MONTGOMERY COUNTY HISTORIC PRESERVATION COMMISSION
STAFF REPORT

Address:	7334 Carroll Avenue, Takoma Park	Meeting Date:	6/14/2023
Resource:	Contributing Resource Takoma Park Historic District	Report Date:	6/7/2023
Applicant:	Rick Leonard (Margo Ricks/Solar Solutions – Agent)	Public Notice:	5/31/2023
Review:	HAWP	Tax Credit:	N/A
		Staff:	John Liebertz

PROPOSAL: Installation of solar panels.

Figure 4: Solar layout (left), section showing attachment of panels to parapet (top right), and elevation (lower right) showing the height of the panels above the roof line. Source: ConnectExplorer.

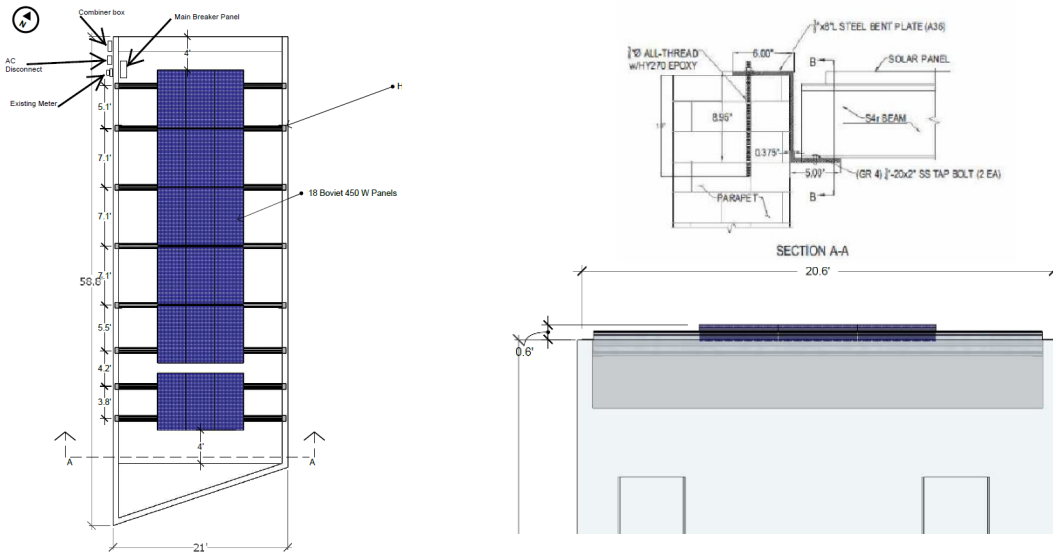
of the flat/shed roof and parapet walls to obscure visibility of the panels from the public rights-of-way. The array would be setback 4' from the northeast corner of the façade and rear elevation. Steel bent plates attach to the parapets and support eight (8) extruded aluminum beams that the panels would be mounted on. As a result, the panels would be only 7.2" above the parapet and would not be visible from the public rights-of-way based on the provided viewshed analysis (Figure 4). These panels would have no adverse effects to the historic resource or the character of the commercial streetscape.¹ The present or future property owners could remove the structural supports and panels in the future with no impact to the historic resource. The applicant, however, should amend the drawings to include the location of the existing chimney stack and HVAC equipment to ensure no conflicts (Figure 3).

1. The applicant shall submit an amended roof plan that show the location of the existing chimney stack and roof-top HVAC equipment.
2. The applicant shall submit an amended drawing that confirms the location of proposed hardware on the south elevation (side) of the building near the existing utility meter.
3. The applicant shall submit all specification sheets for the combiner box and AC disconnect.

Figure 5: Detail from Sheet PV.01 (left) and A.01 (right). Staff requests clarification regarding the placement of the combiner box and conduit. Source: Applicant.

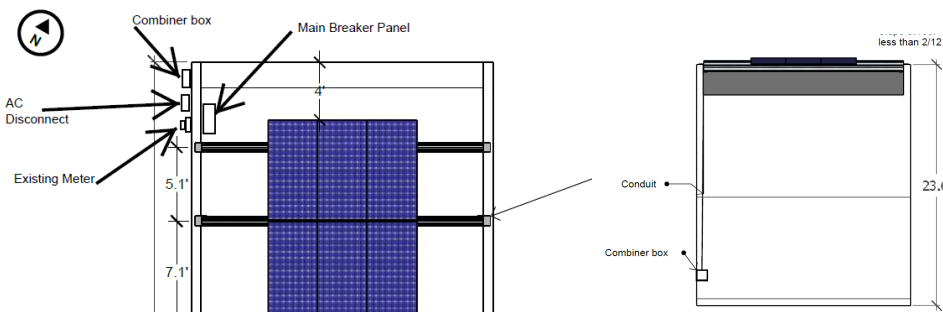
Staff recommends approval for the placement of the exterior hardware and conduits associated with the solar array with conditions. *Policy Guidance #20-01: Solar Technology (2021)* states that all conduits for connections to electrical meters should be placed on the inside of the building or on a secondary elevation. The proposal has a discrepancy between Sheet A.01 and PV.01 which shows the combiner box on the rear and side elevations, respectively (Figure 5). Sheet A.01 should be amended to show the combiner box and AC disconnect on the side (south) elevation as depicted in Sheet PV.01. Specification sheets for the combiner box and AC disconnect should be included as well. Also, the applicants should submit additional details (an elevation or annotated photograph) regarding the treatment of the conduit wire with respect to the parapet. The wire should pierce the wall and not be placed over the parapet.
